CITY PLAN COMMISSION STAFF REPORT

Falk Quarry

CD-CPC-2024-00152

The applicant is seeking approval of a major amendment to an approved development plan to incorporate new phasing and building layout, in District M2-2 (Manufacturing) to allow for the existing land reclamation, quarry, excavation, office, commercial and warehouse development.

④ North Elevation
3/32" = 1'-0"

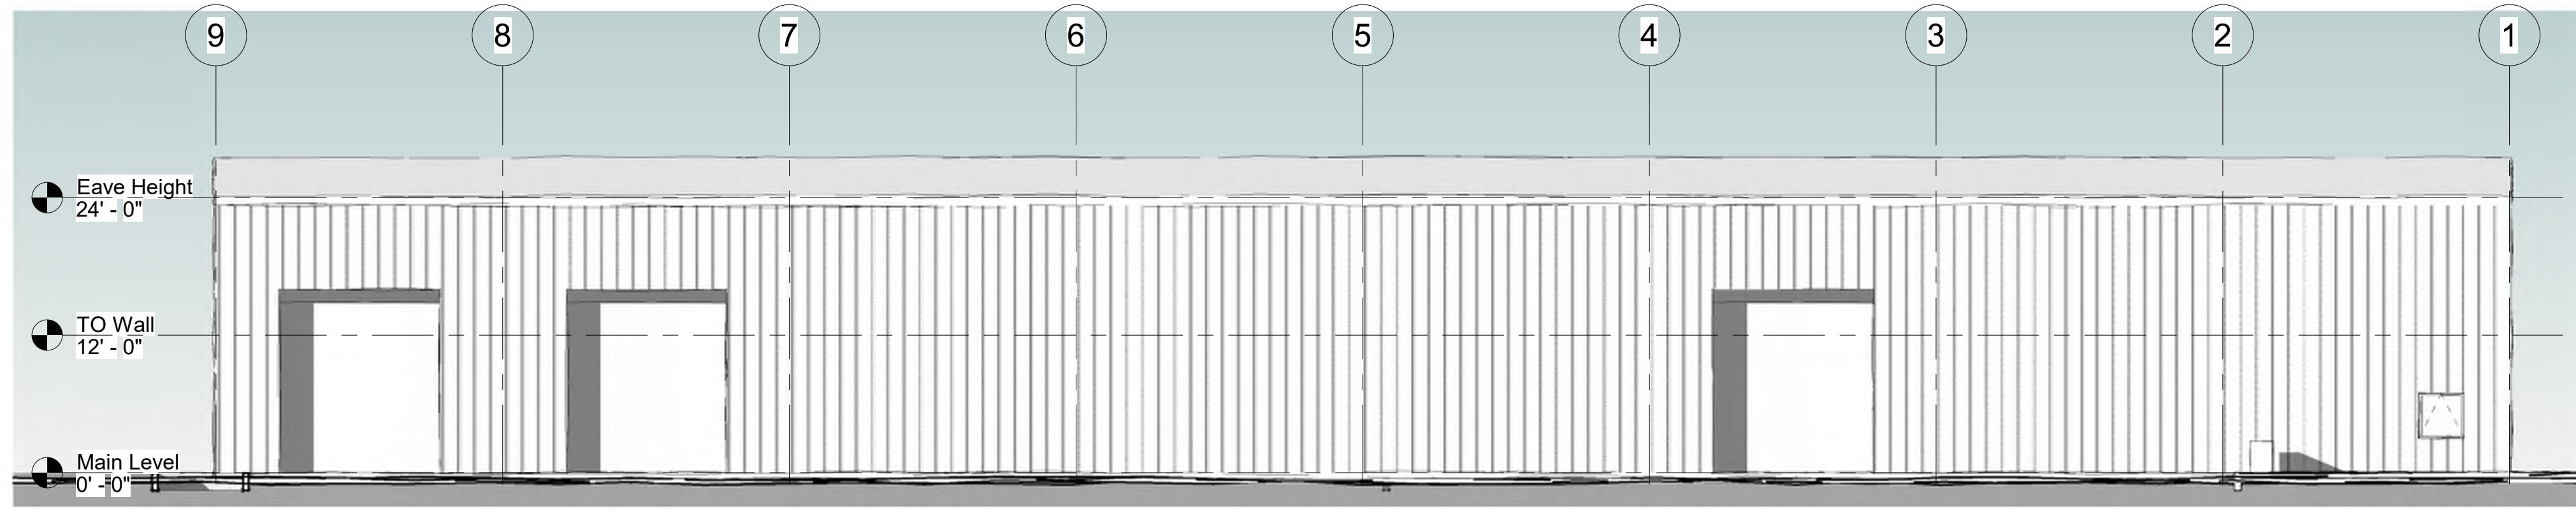
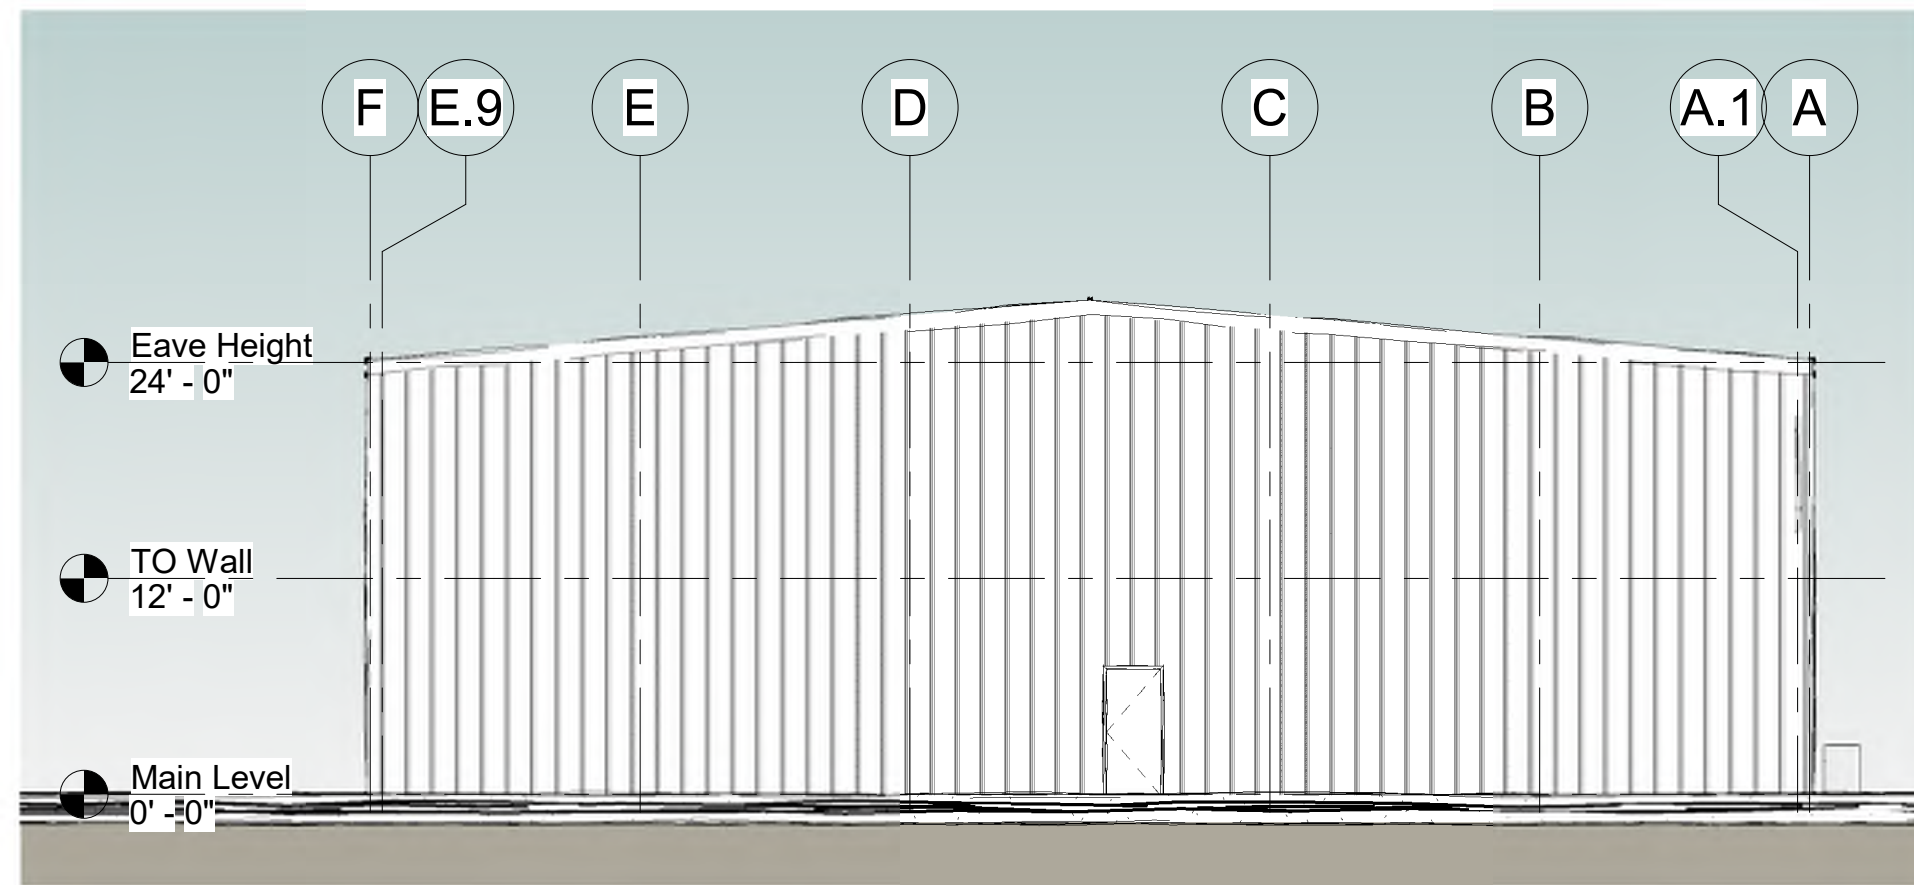
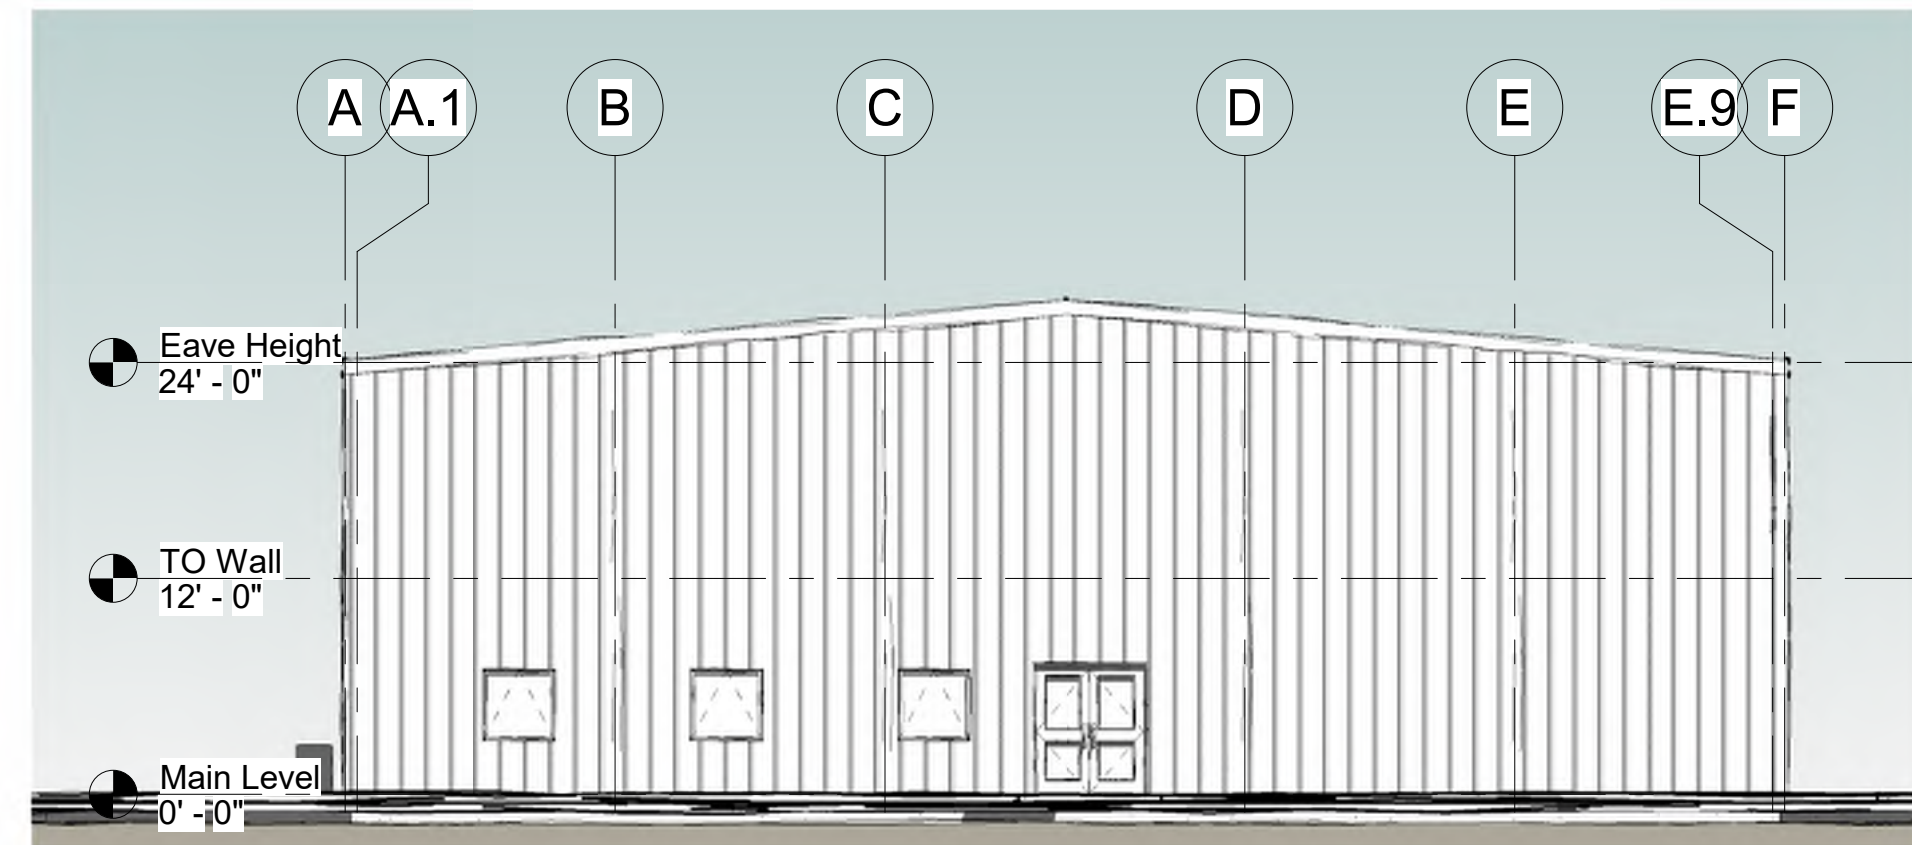
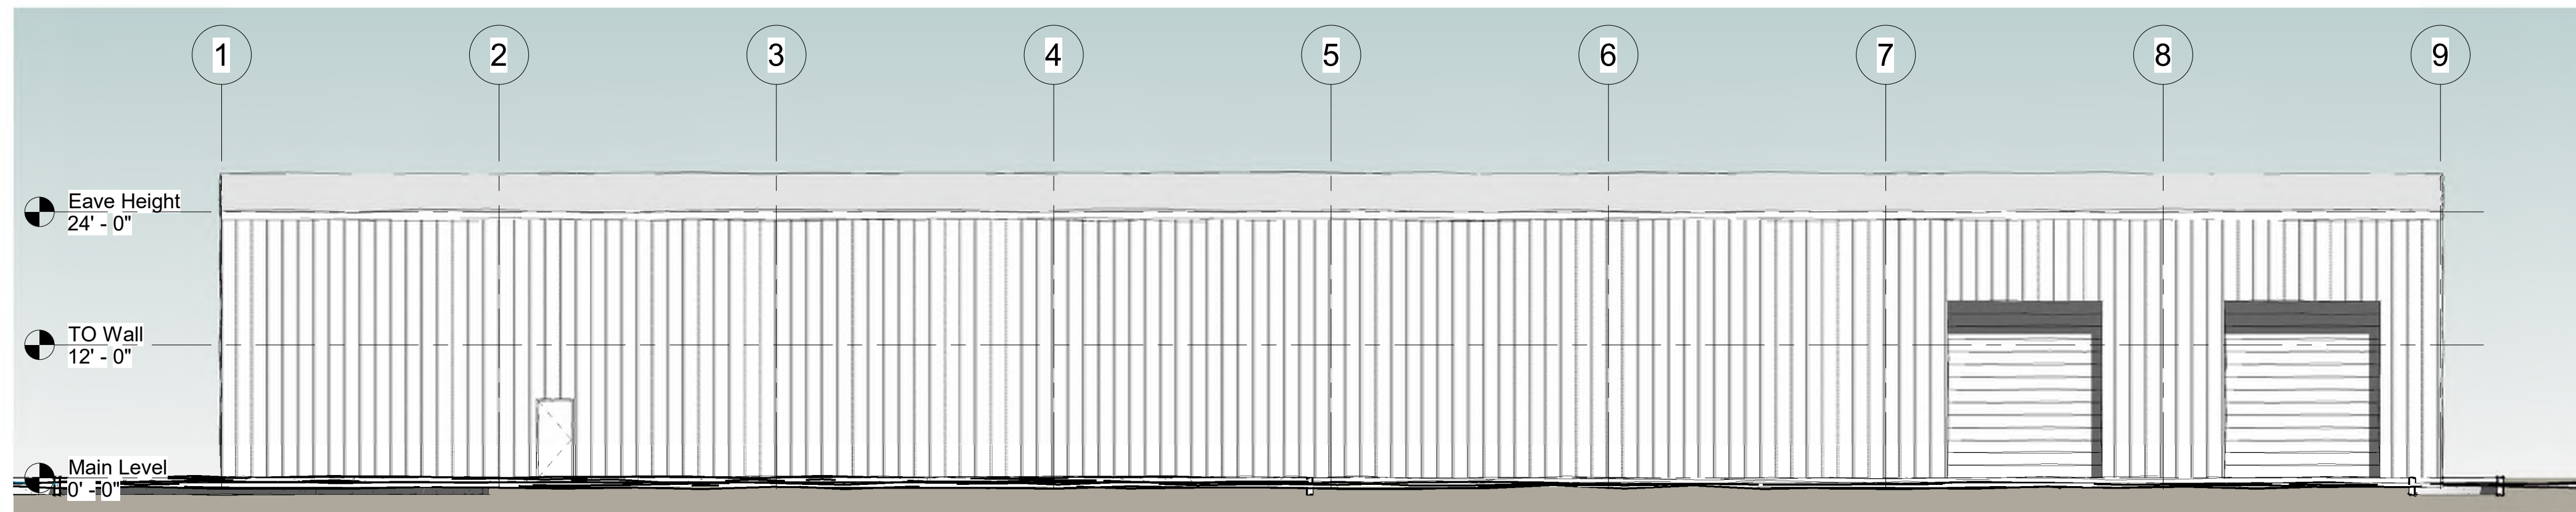
The developer submitted a typical metal building plans with elevation without material descriptions and details. This building will not be visible from the public right of way. (OA)
